PRELIMINARY DRAINAGE REPORT

Storyrock Phase 1A

Drainage Review Memorandum

Re: Storyrock - Phase 1A
Case number: 5-PP-2016

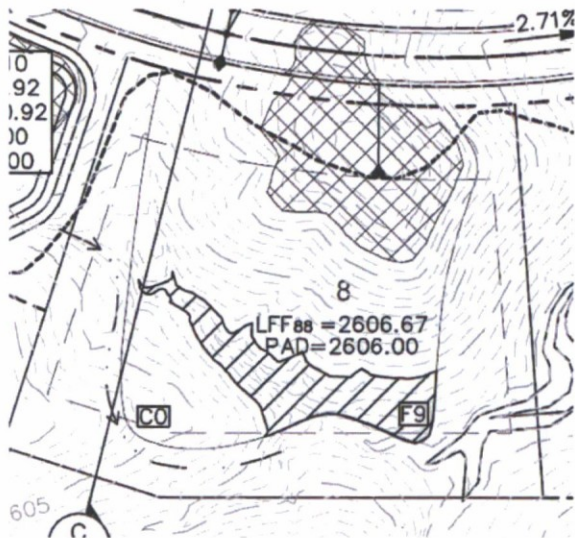
- i. **COS 1st Review:** The presence of smaller washes will need to be clearly indicated on the plan via flow line and 100-year flow rate. For example, it is unclear if there is a moderately sized wash located south of lots 28 through 31. Approximate 100-year floodplain limits should be shown and labeled on moderate to larger sized washes impacting proposed lots or other improvements.

KHA Response: Limits of inundation are shown and identified for flows greater than 50 cfs throughout the development. Grading has been provided if wash/swale grading impacts ridgelines or other areas on the property. Additional drainage swales have been added to the plan, indication to indicate how flows are routed around lots and roadways when necessary.

Grading & Drainage Plan – Lot 8 (Sheet 6 of 8):

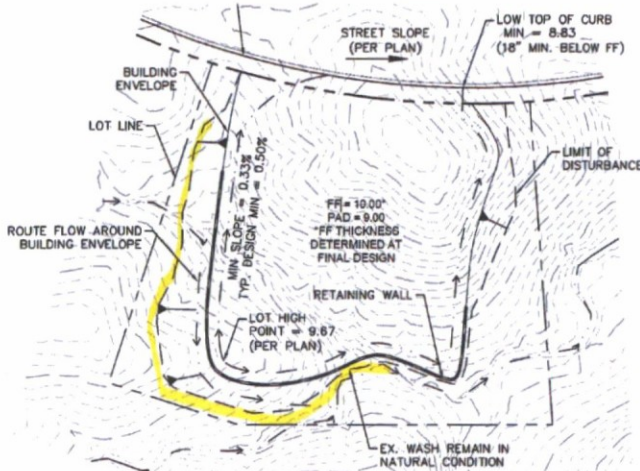
COS 2nd Review: Additional drainage swales depicted on the plan are missing proposed limits of disturbance associated with grading of ridge lines. Latest limits of disturbance should be reflected in NAOS area analysis tables and exhibits.

KHA 2nd Response: Proposed limits of disturbance has been updated for the project and the associated NAOS areas and analysis tables/exhibits have been revised to reflect the changes. Limits of disturbance for the project match NAOS calculations and accommodate grading associated with drainage swales adjacent to improvements. It is important to note that in many locations, the drainage swales proposed will be revegetated NAOS and graded in a natural state.

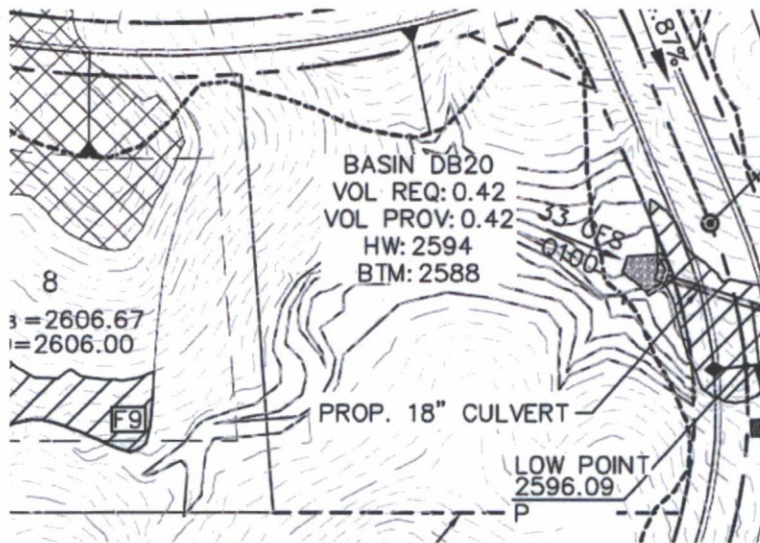
COS 2nd Review: Depict above discussed access barrier. Will this barrier extend along roadside to prevent access? Add existing contour labels. Is solid contour line in the figure below limits of inundation? Please address culvert sedimentation.

KHA 2nd Response: As discussed in our meeting with the City on April 12, the safety barrier referred to in our original comment response is intended to be a standard headwall safety rail, similar and most common with roadway culverts throughout the City. DB 20 will operate in similar fashion to any incised wash crossing in Scottsdale ESLO in a majority of the storm events and only experience depths greater than 3 feet for a very minimal timeframe, as provided in the drainage report. Again, this is similar to a majority of roadway culvert crossings throughout the City of Scottsdale and is acceptable per the City's DSPM. The adjacent roadway

Contour labels have been provided in this area for clarity. The solid contour line indicates the limits of inundation with a total drain time of only 0.14 hours.

Sedimentation is minimized with this crossing by maintaining existing wash grades and velocities through the culvert. Furthermore, the total flow for this crossing is only 33 cfs which is less than significant flow per the City's DSPM. The HOA will be responsible for maintaining the culvert and upstream condition of the inlet to remove periodic sedimentation that may occur. As discussed with the City, a maintenance report could be provided by the HOA to the City twice a year or after a larger storm event documenting the condition of the culvert crossing for DB 20 and any sedimentation removal performed. A discussion has been added to the drainage report.

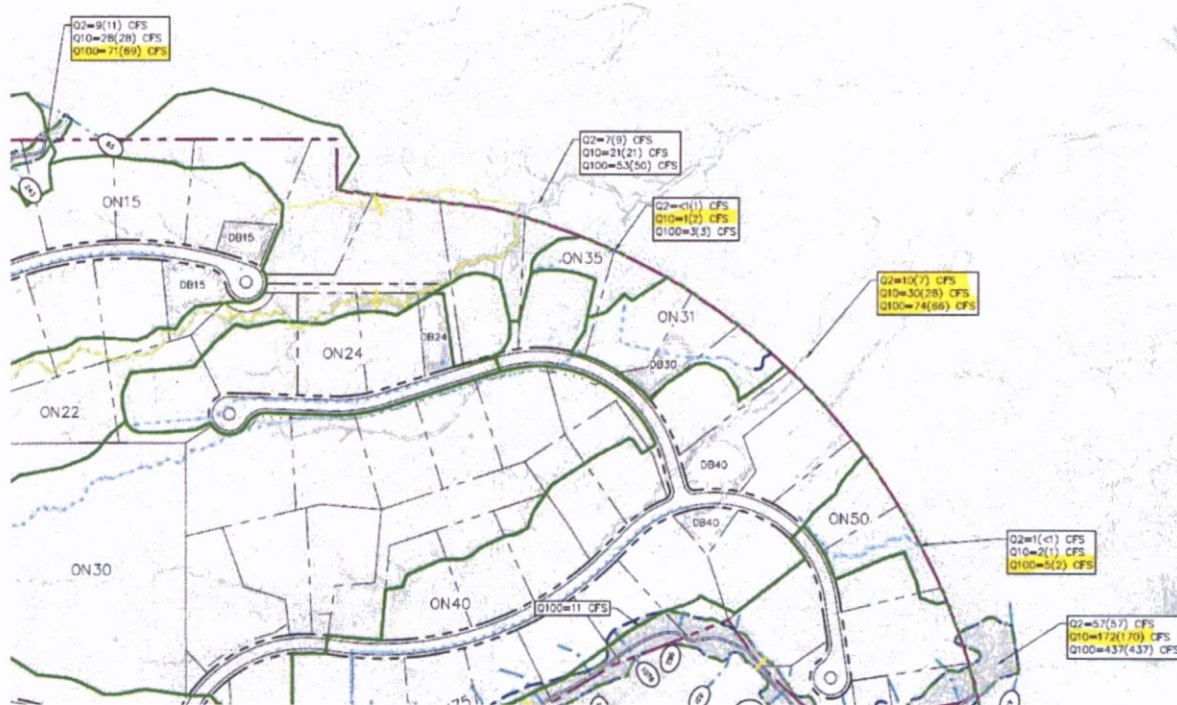
7. **COS 1st Review:** The preliminary drainage report will need to illustrate the project is meeting first flush requirements in general. The report should address whether proposed stormwater storage basins have been sized to meet the first flush requirement.

KHA Response: Detention basins proposed in the development meet first flush criteria. Some areas throughout the property propose to directly discharge into washes/channels that meander through the property. These areas have been identified in the drainage report and on the preliminary grading plan for alternative methods to stormwater pollution such as a stormceptor inlet structure. These areas are specifically proposed for alternative methods because the existing terrain and locations do not provide for adequate space or ability to grade a first flush basin to meet requirements. Furthermore, existing grades in these areas far exceed 5% slope and in some areas may require blasting. Stormceptor systems would be contained within the roadway tracts proposed and provide for an acceptable method to mitigate stormwater pollution exiting the property, however, additional alternatives may be proposed at final design and provided to staff for review and approval.

Figure 4. Proposed Drainage Condition.

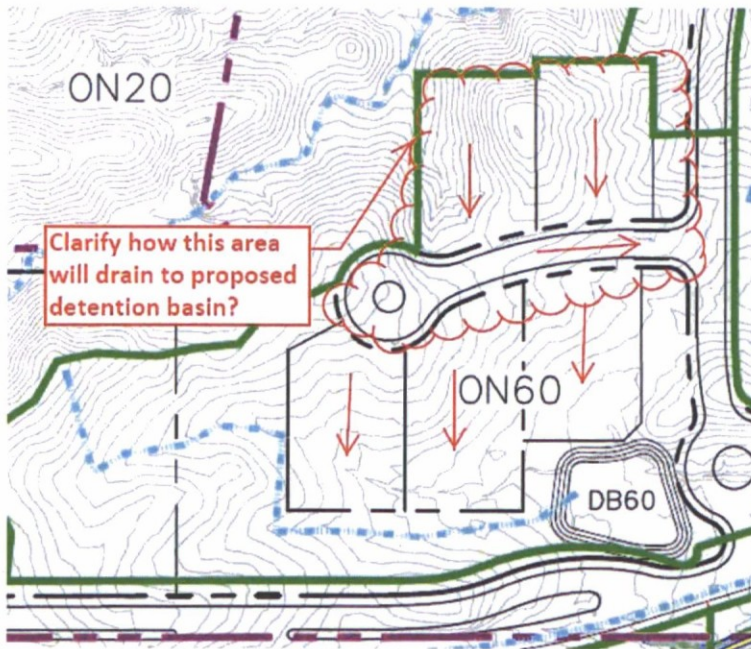
- COS 1st Review:** Provide sufficient level of information to demonstrate how proposed on-site watersheds will be routed through stormwater detention facilities. Add flow direction arrows to Figure 4, Proposed Drainage Condition map to clearly demonstrate intended flow patterns. HEC-1 model proposes routing of most watersheds through detention facilities in effort to reduce post development peak flows. See sample watershed below, how are the two northerly lots draining to proposed detention basin? Preliminary Grading and Drainage plan (sheet 6 of 8) does not show flow interception and routing to the proposed detention basin, that is not consistent with HEC-1 analysis.

KHA Response: Figure 4 and preliminary grading plan have been updated to better show proposed routing of onsite flows.

Preliminary Grading and Drainage Plan. Sheet 6 of

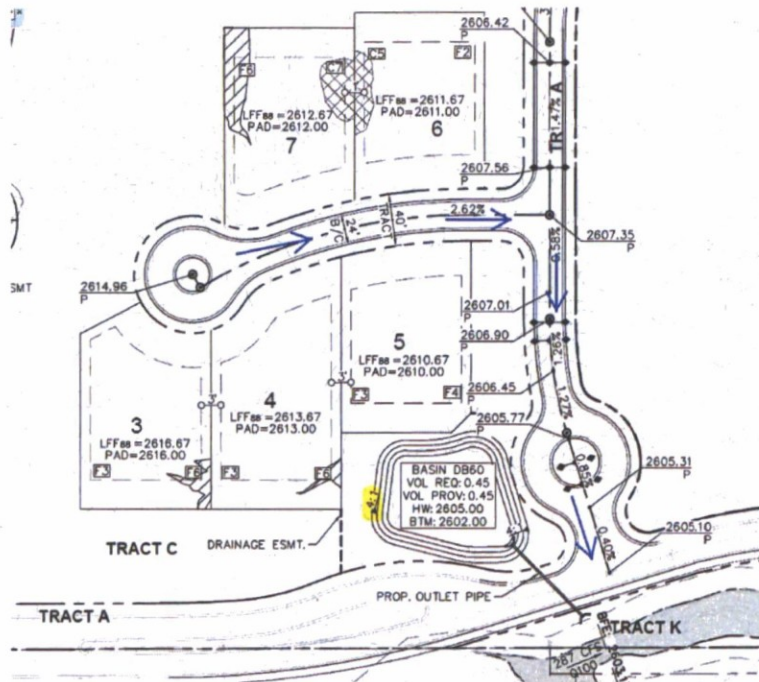
COS 2nd Review: Please identify limits of disturbance associated with proposed swale and wash re-routing. Call out flow line elevations.

KHA 2nd Response: Limits of disturbance associated with proposed swales and construction envelopes have been added to the plan in addition to the roadway grading limits previously shown. Swale flow lines have been revised to correspond with the disturbance limits more appropriately and contour labels have been increased to better review flow grades in comparison to adjacent improvements.
